Detroit
Edison

February 21, 1991
NRC-90-0187

Subject: Proposed Technical Specification Change (License Amendment) - Pressure-Temperature Limits

Figure 2. Limiting Beltline AFT versus EFPY

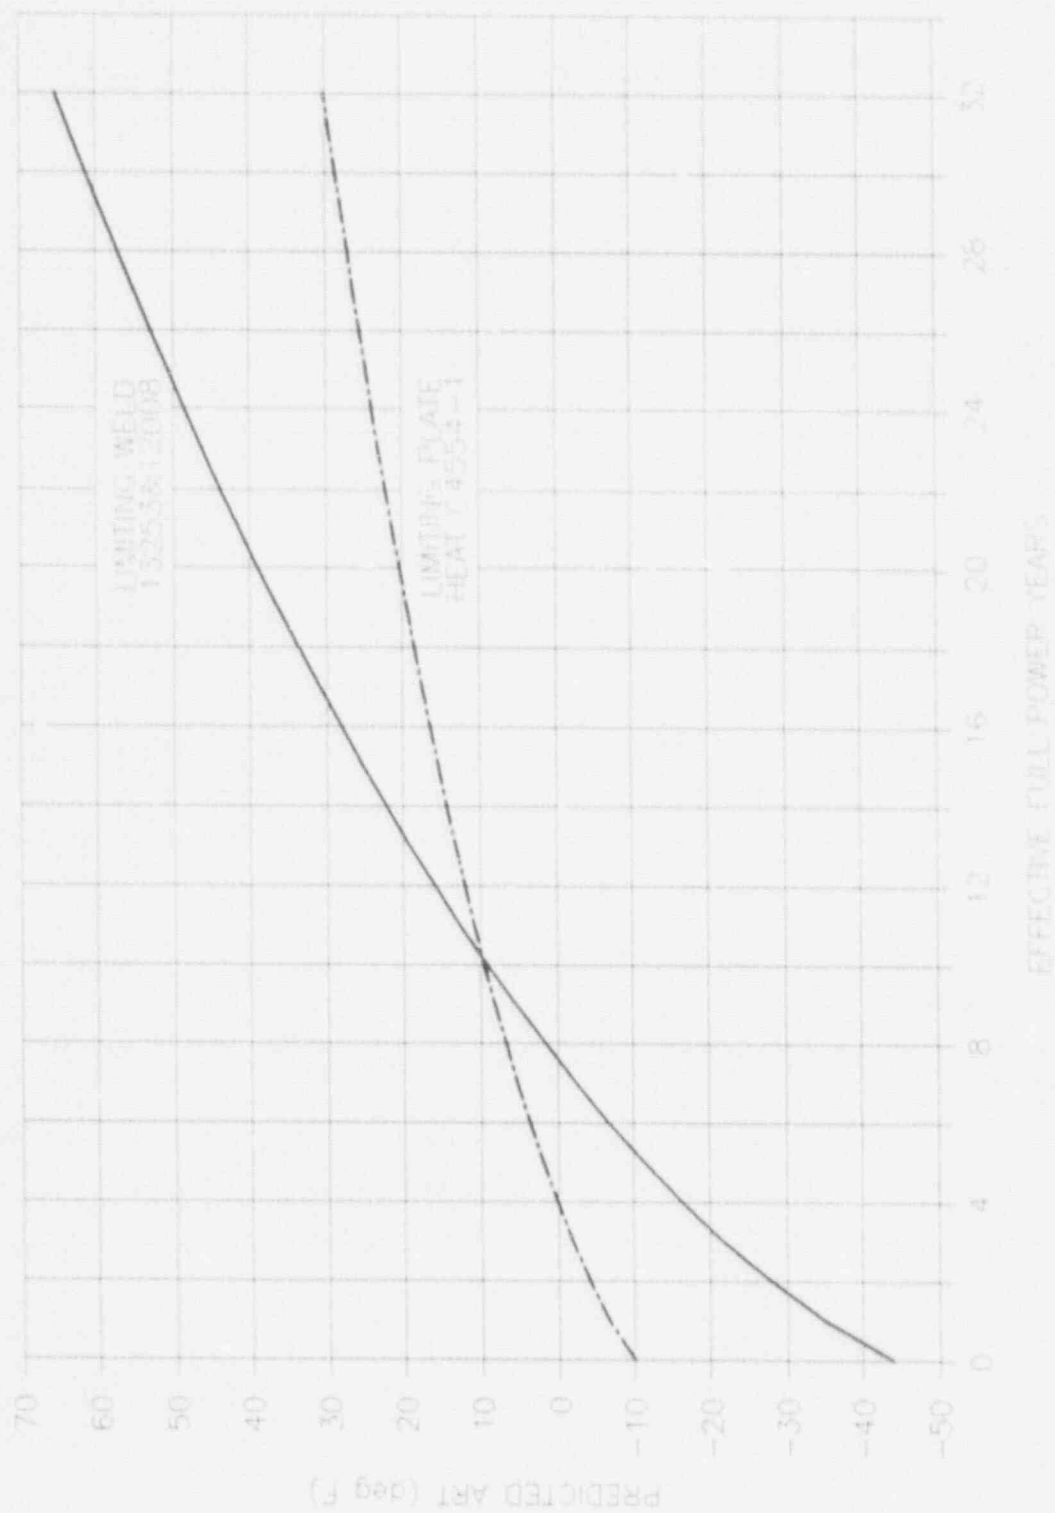
The values of ART in Appendix A are computed by adding the SHIFT terms to the values of initial RT_{NDT} . Predicted ART values versus EFPY is plotted for the most limiting beltline conditions in Figure 2. As seen, the beltline plate with the highest initial RT_{NDT} and Cu content is limiting through about 10 EFPY. For operation beyond that time, the tandem arc beltline weld is limiting.
